VINEYARD PLANNING COMMISSION MEETING**Site Visit: West End of 1600 North @ 5:30pm****Public Hearing and Regular Meeting: Vineyard City Offices, 125 S. Main Street
Road, 6:00pm****Tuesday, February 19, 2019**

Date: February 19, 2019
From: McKenna Marchant, Planning Tech
To: Planning Commission
Item: Site Plan Application – MS Properties
Address: Parcel #38:424:0012
Applicant: MS Properties

The applicant is requesting site plan approval for a warehouse building. The property is located on the west end of 1600 N within the Flex Office & Industry (FOI) district. The building is located on 3.69 acres of the subject property. The applicant is proposing approximately 60,000 square feet of office/warehouse/manufacturing building.

Site Plan

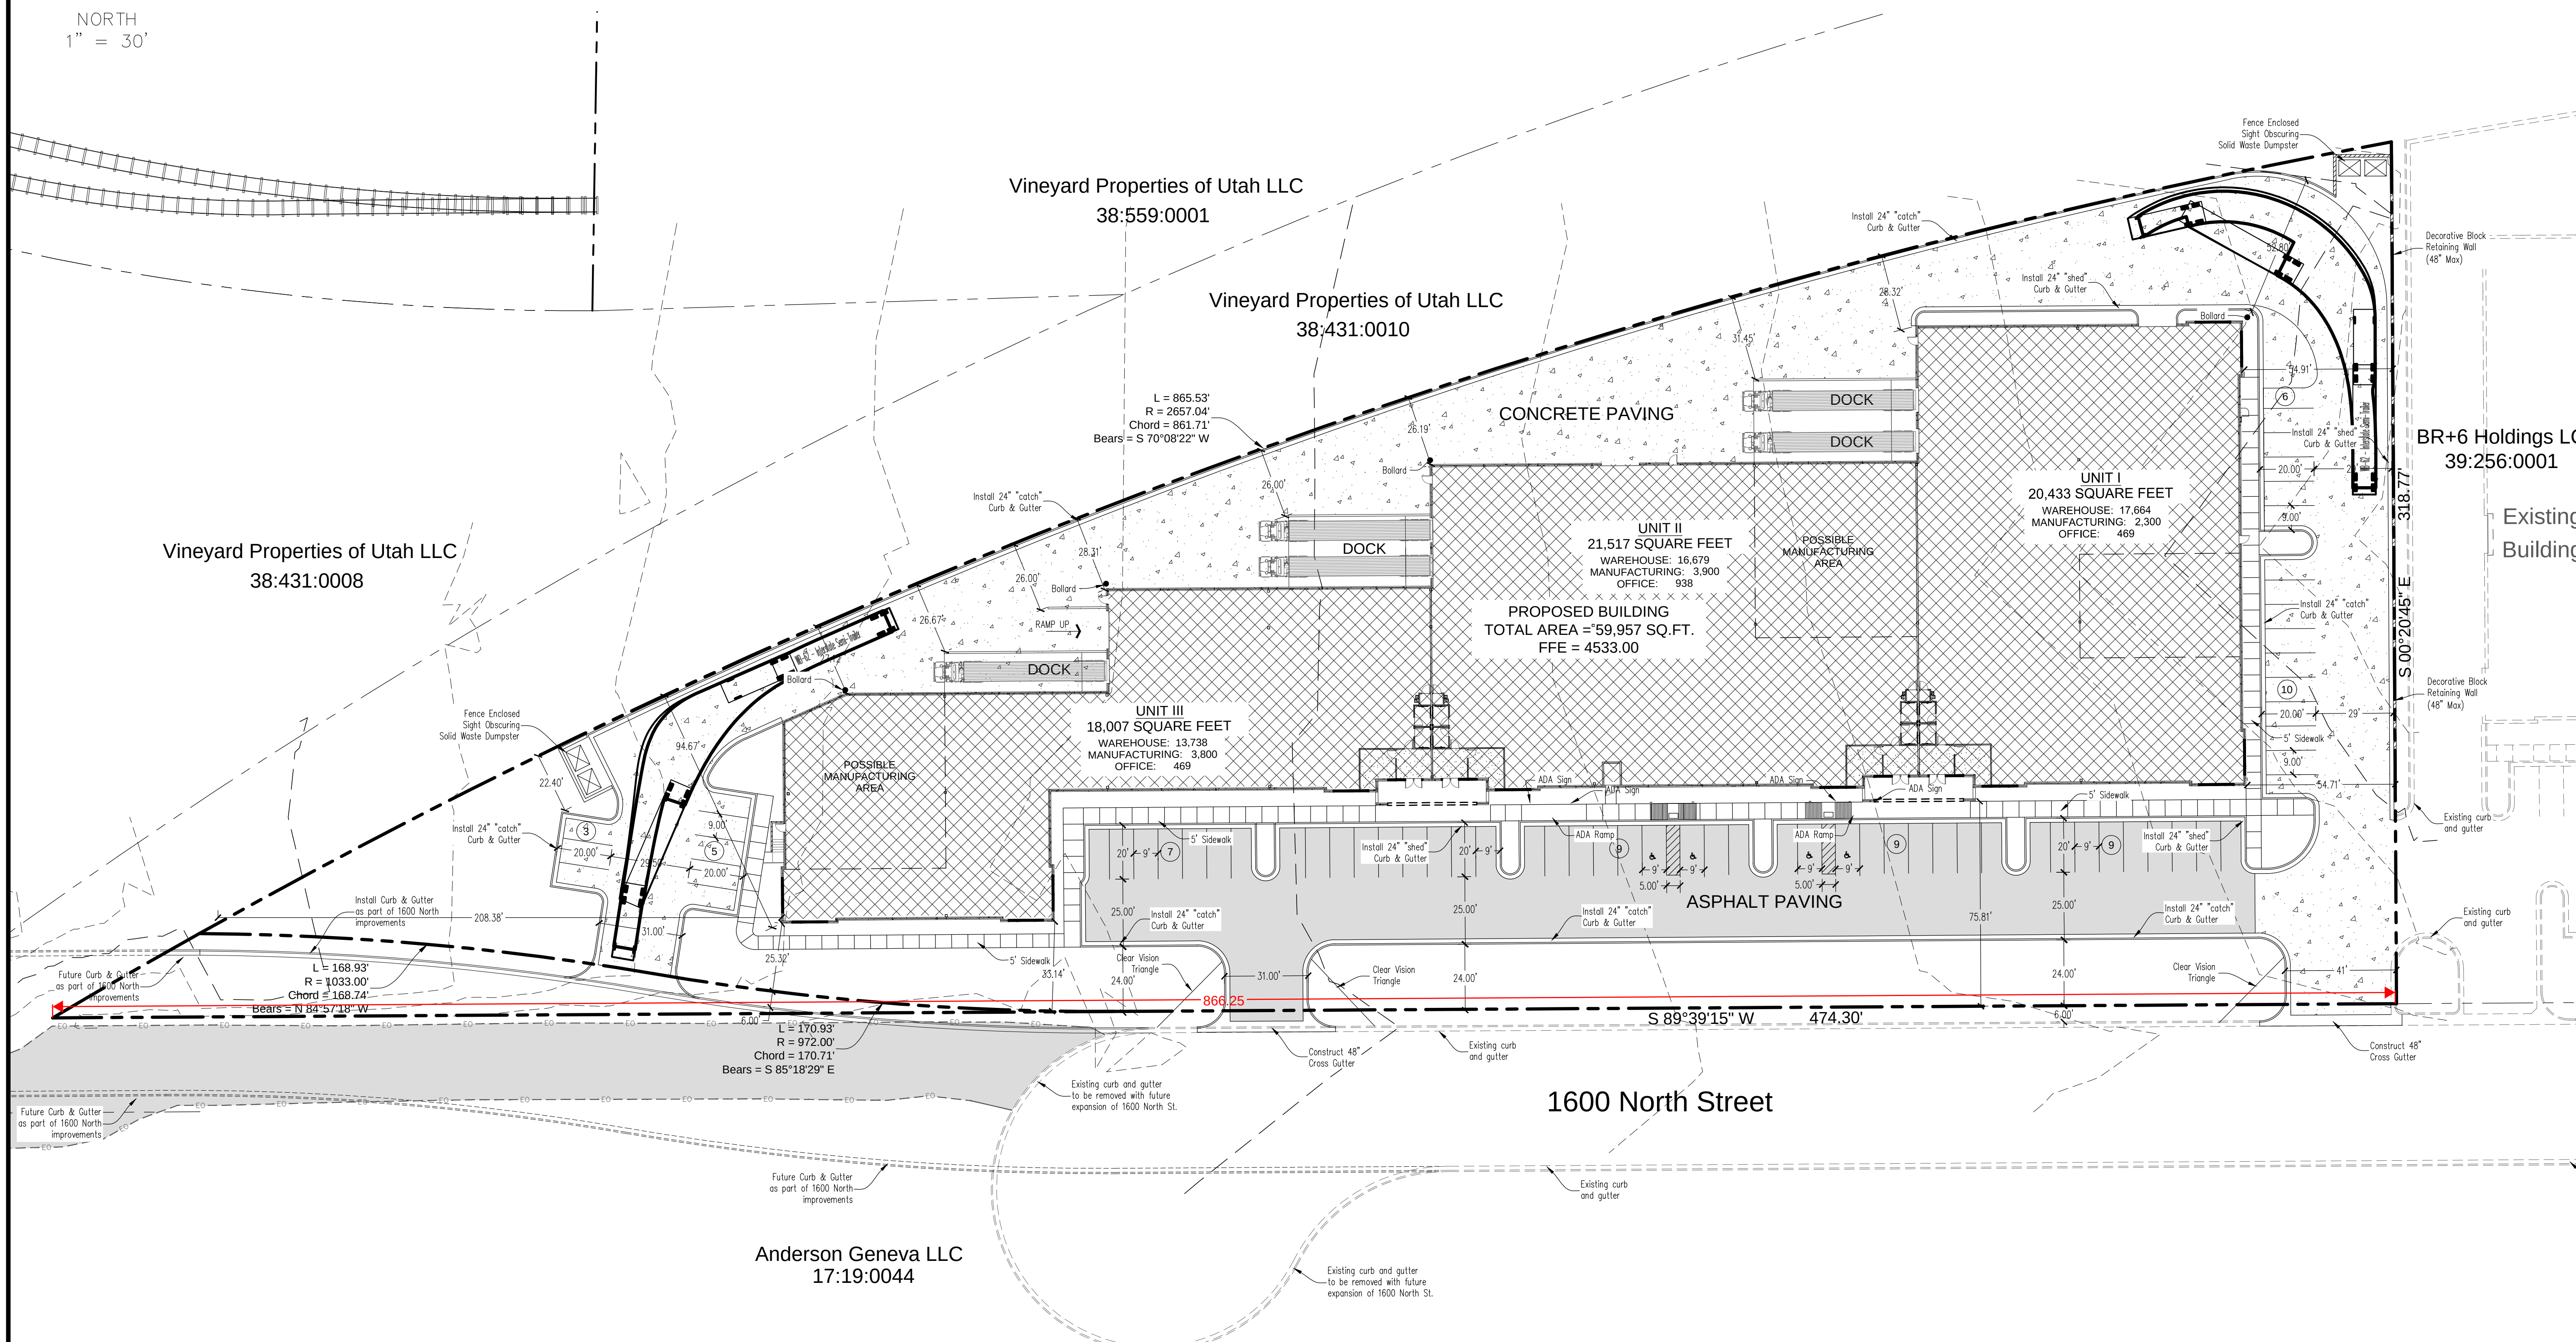
.040.a.7	Bumper rails shall be provided at locations where needed for safety or to protect property.	Yes (need to be shown on updated site plan)
040.a.10	Off-street loading facilities shall be located on the same site with the use for which the berths are required.	Yes

1. The applicant works with staff on the street frontage landscaping and receive staff approval prior to a building permit being issued.
2. The applicant submits a site lighting plan to staff.
3. The applicant pays any outstanding fees and makes any redline corrections
4. The applicant is subject to all local, state and federal laws.

SHEET NO.
A-2

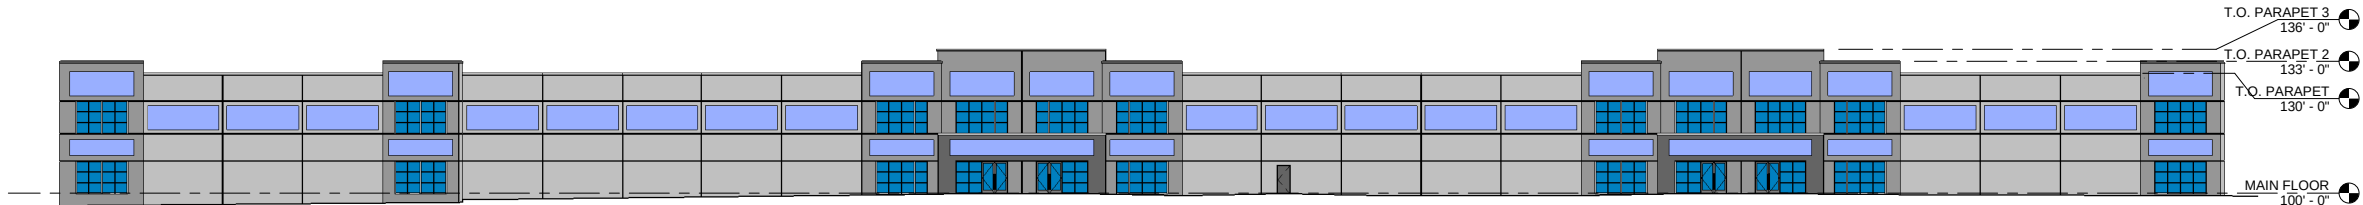
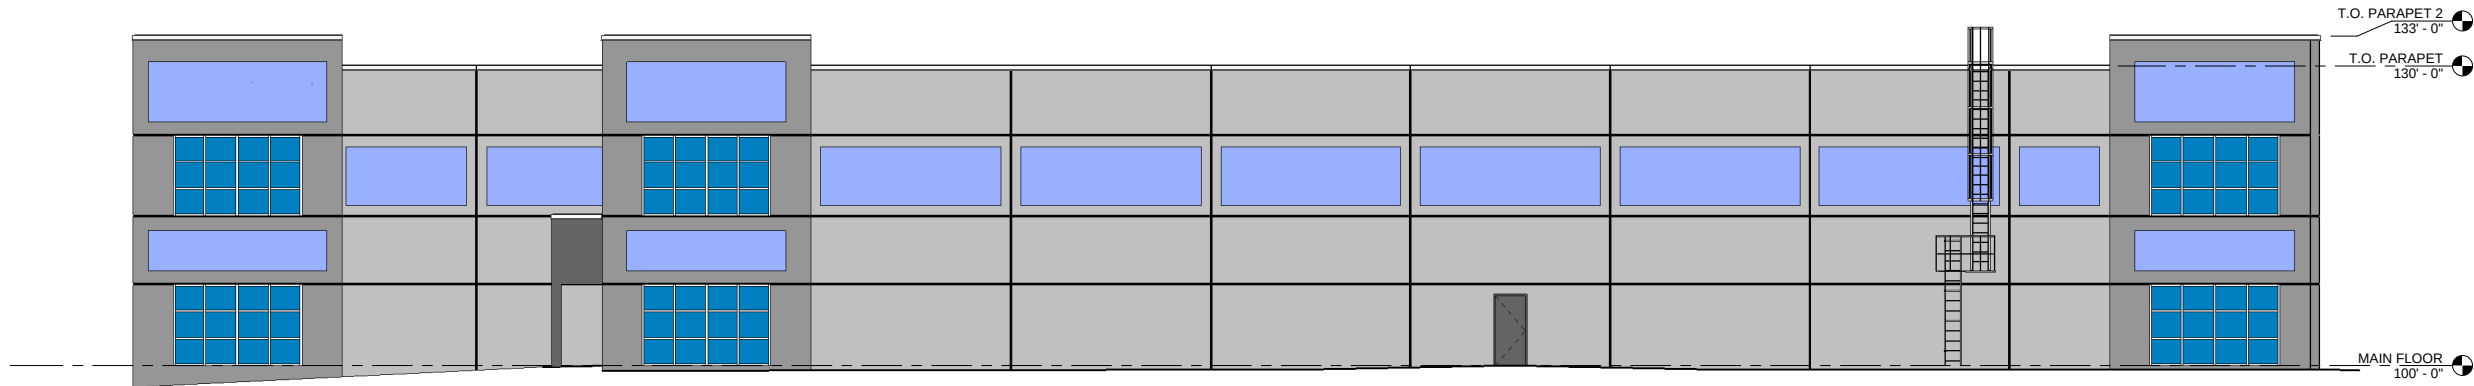
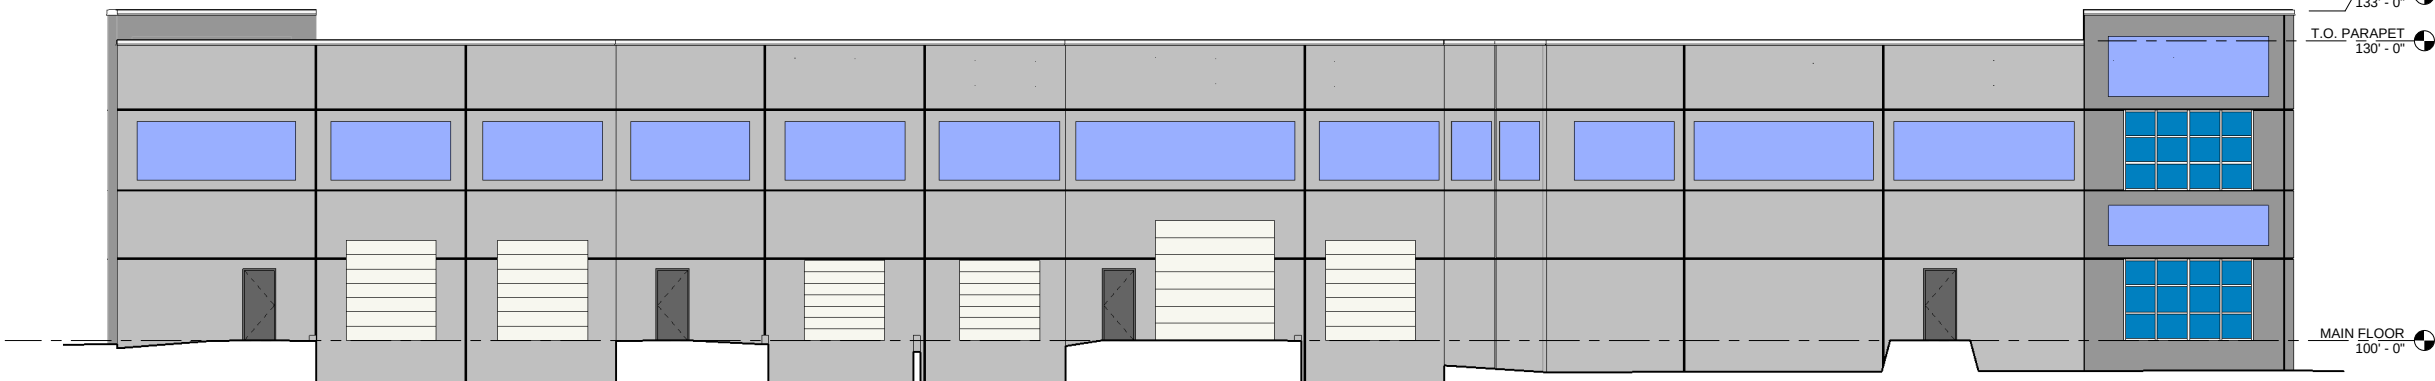
030.1.a.ii.1 Coherent Building Design	All sides of a building shall be coherently designed and treated. A façade not related to the rest of the building shall be avoided. A consistent level of detail and finish on all sides of a building shall be provided.	There is a consistent level of detail and finish on all sides of the building.

030.1.a.ii.2.	Continuous building wall surfaces shall be relieved with variations of wall planes or overhangs that create shadow areas and add visual interest.	The rear elevation has multiple building pop-outs that create shadow areas and add visual interest to the rear. The front façade has entry ways that create shadow areas.

030.1.a.v. Visual Patterns	All buildings shall have shadow relief created by recesses and projections.	The rear elevation has multiple building pop-outs that create shadow areas and add visual interest to the rear. The front façade has entry ways that create shadow areas.

030.1.a.vi. Architectural Details	Surface details, ornaments, and other building elements that enrich the character of a building are encouraged. Stonework, Exposed beams and columns, cornices, moldings, bands, pop-outs, decorative vents, cast or sculpted features, covered entries, patios, walkways, breezeways, bay and balconies, enclosed courtyards and patios, trellises, landscape areas and wide roof overhangs, accessories such as art features, benches, pots, lamps, artwork and sculptures.	The front façade has covered entries that also pop-out from the wall.

030.7. Building Materials and Textures	Exterior building materials shall be similar to and compatible with those found in a rural setting. Are encouraged in natural colors or earth tone finishes	There will be a natural three tone color scheme to match surrounding valley.
.030.4 Mechanical Equipment	Air conditioning units, generators and other auxiliary mechanical and building equipment shall be placed at locations where they will be least intrusive in terms of noise, appearance, and odors, particularly for adjacent properties and public rights-of-way. Screening Walls, landscaping, and other screening treatments shall be used so all required mechanical equipment screened from public streets and adjoining properties. All building-mounted mechanical or communications equipment shall be a color to make it as unobtrusive as possible. If located on	The parapet walls conceal the mechanical equipment on the roof.

Eastlake Lot 12
Landscape Plan
Utah
Vineyard

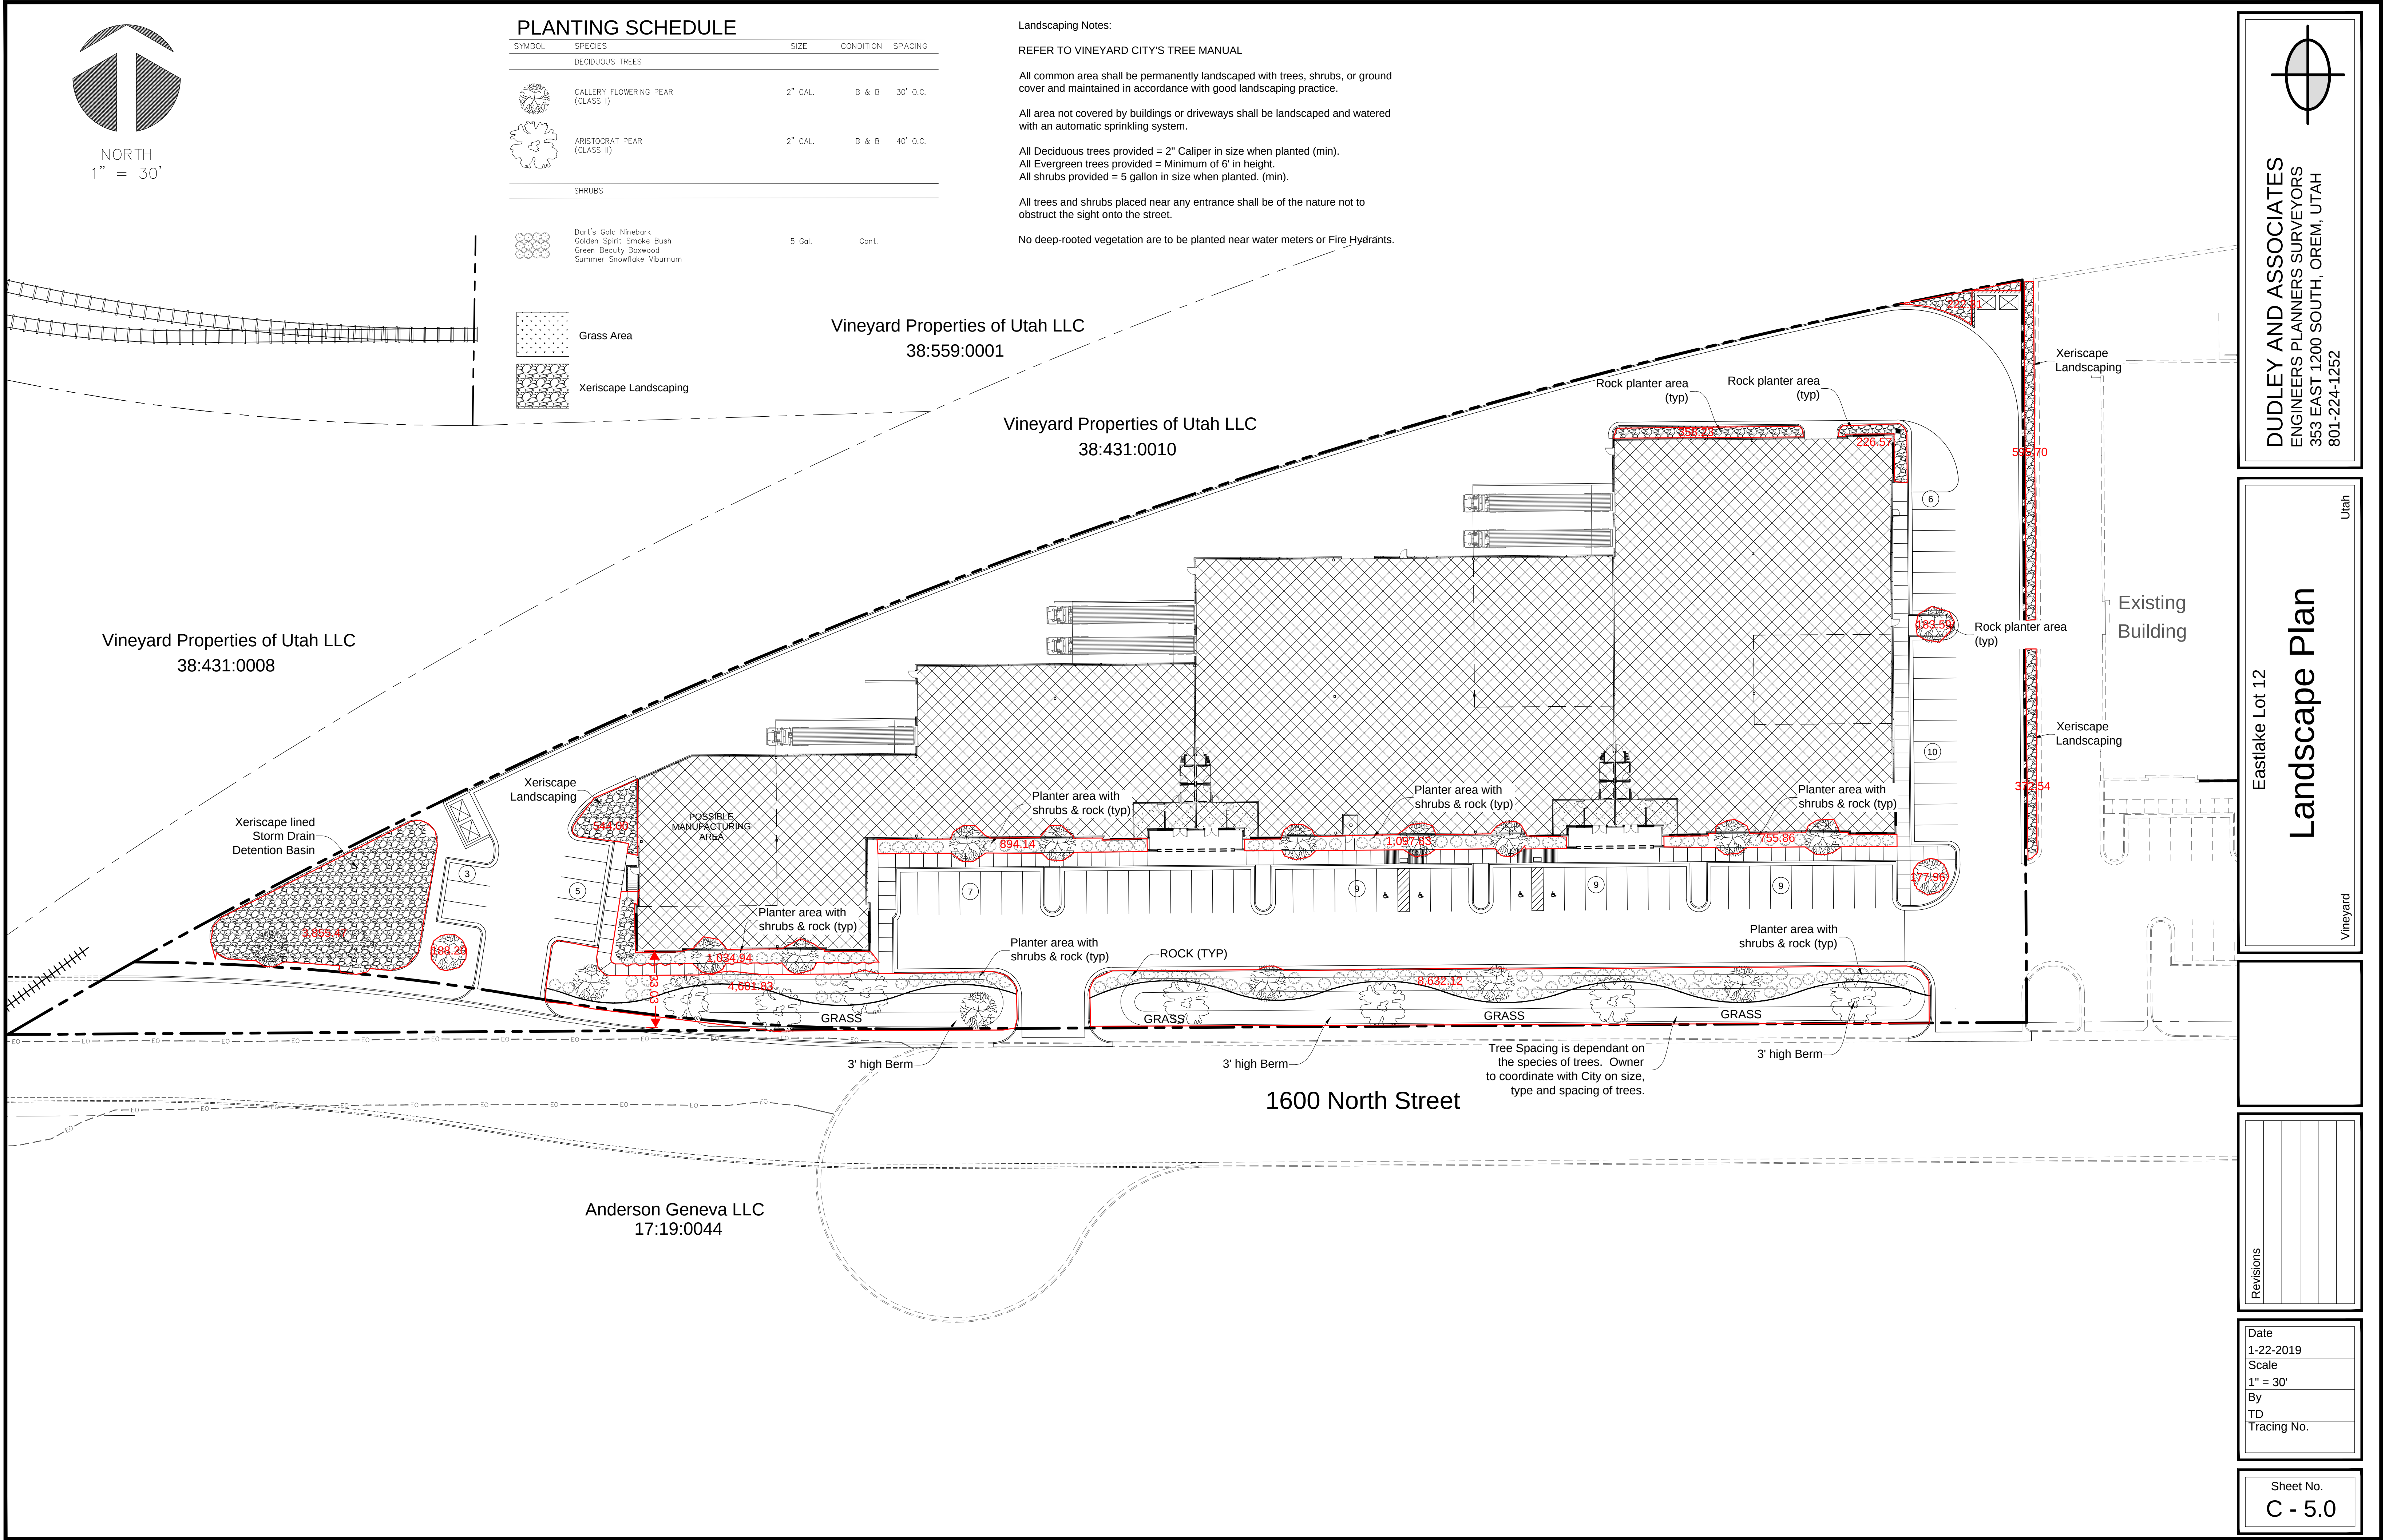
080.1.b. Minimum Size of Plantings	All required deciduous trees shall be a minimum of two-inch caliper in size. All evergreen trees shall be a minimum of 6-feet in height. All shrubs shall be a minimum of 5-gallon in size.	Planting Schedule specifies that both trees varieties (Emerald Queen Maples and Spring Snow Crab Flowering Crab are two-inch caliper. Shrubs are specified to be 5-gallon size

080.2.a. Onsite Landscaped Areas	For all development within the industrial zoning districts, landscaped areas shall be provided on the site in an amount equal to or greater than five (5) percent of the net site area, whichever is greater.	Total Site Area: 60,285 SF Required Landscaping: 3,014 SF Existing/Proposed: 23,440 SF

Street Frontages	The landscape setback, measured from the property line, for non-residential and multi-family uses shall be as follows: Collector Streets: 20 feet	
080.6.e	The installation of street trees, shrubs and vegetation groundcover shall be required for all applicable projects in an amount equal to or greater than one (1) tree and ten (10) shrubs for every twenty (20) feet of street frontage.	Staff is proposing a condition of approval that would require the applicant to work with staff on the spacing and number of trees and shrubs for this site due to there are discrepancies between the zoning ordinance and the Vineyard Tree Manual, the applicant would have to do this prior to a building permit being issued.
